Type	S/Section
TWINGO	X06 X	41

ADAPTING A SPECIFIC STRUT FOR ENGINE TYPE C3G

- Engine : XXX
 - Gearbox : XXX
- Basic Manual : M.R. 306

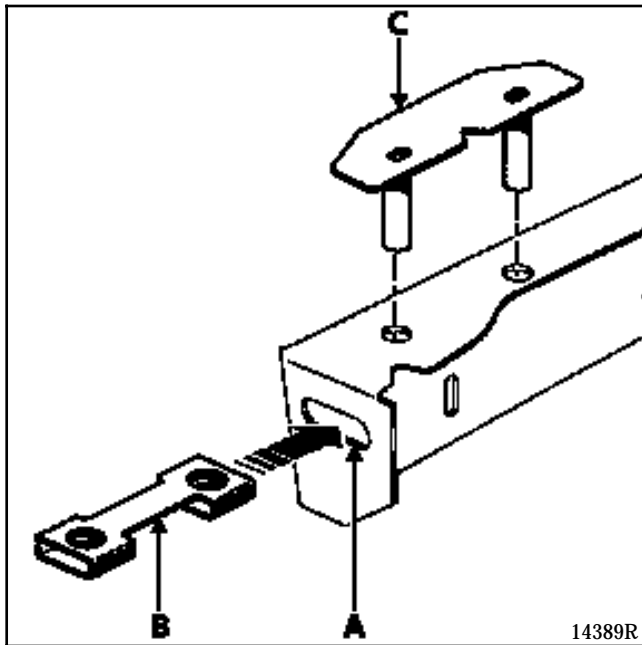
For reasons of standardisation, the Parts Department is only supplying bodyshells or side members for engine types D7F.

As a result, when replacing a bodyshell or side member for a C3G engine it will be necessary to order the following in addition :

- a specific strut

Part No. : 77 00 426 738

- a coil bracket

Part No. : 77 50 820 988

Insert the lower plate (B) through the aperture in the side member closing panel (A).

Position the upper plate (C) in the holes (Ø 28 mm) on the upper section of the closing panel.
